PREPARED FOR THE PLAN COMMISSION

Project Address: 1402 Wyoming Way (18th Alder District)
Application Type: Conditional Use
Legistar File ID # [89234](#)
Prepared By: Chris Wells, Planning Division
Report includes comments from other City agencies, as noted.
Reviewed By: Timothy M. Parks, Planning Division

Requested Actions: Consideration of a conditional use in the Suburban Residential-Consistent 1 (SR-C1) District for a school, public or private, and consideration of a conditional use in the SR-C1 District for a building or structure exceeding 10,000 square feet in floor area to allow construction of a new public school building to replace the existing school building (Black Hawk Middle School and Gompers Elementary School) at 1402 Wyoming Way.

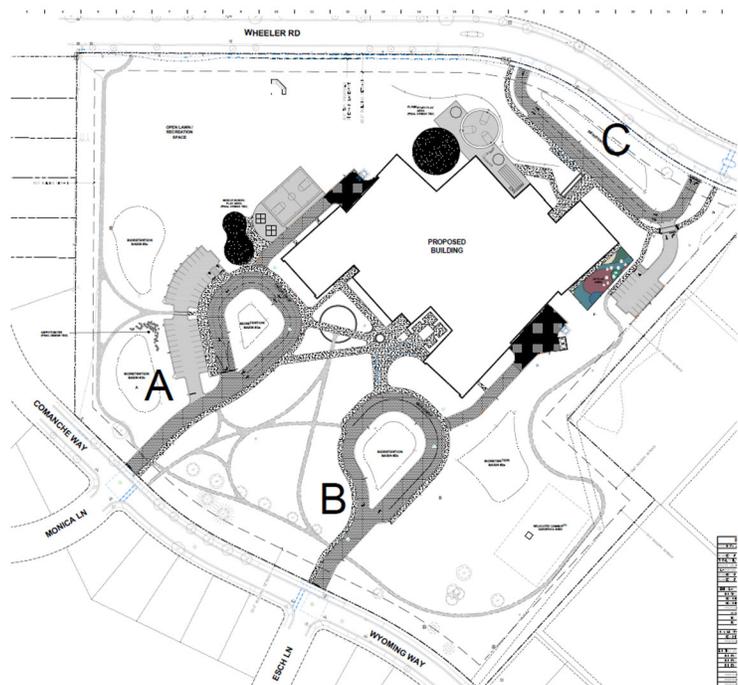
Gompers Elementary School will have a dedicated looped drop-off for automobiles located along Wheeler Road (labelled “C” in the graphic to the right). It will also provide access to 15 automobile surface parking stalls. The school’s main entrance is located along the building’s northeast façade, and provides access to the upper floor.

Black Hawk Middle School’s dedicated access will be located along Comanche Way/Wyoming Way, at the southwest corner of the site, directly across from the intersection with Monica Lane. (It is labelled “A” in the graphic to the right.) This access with looped turnaround will be used for the drop off/pick up of middle school students and will also provide access to 41 surface automobile parking stalls.

The third access, located along Wyoming Way, across from the intersection with Esch Lane, will be used by yellow school buses and para-transit vehicles for students of both schools. It is labelled “B” in the graphic to the right.
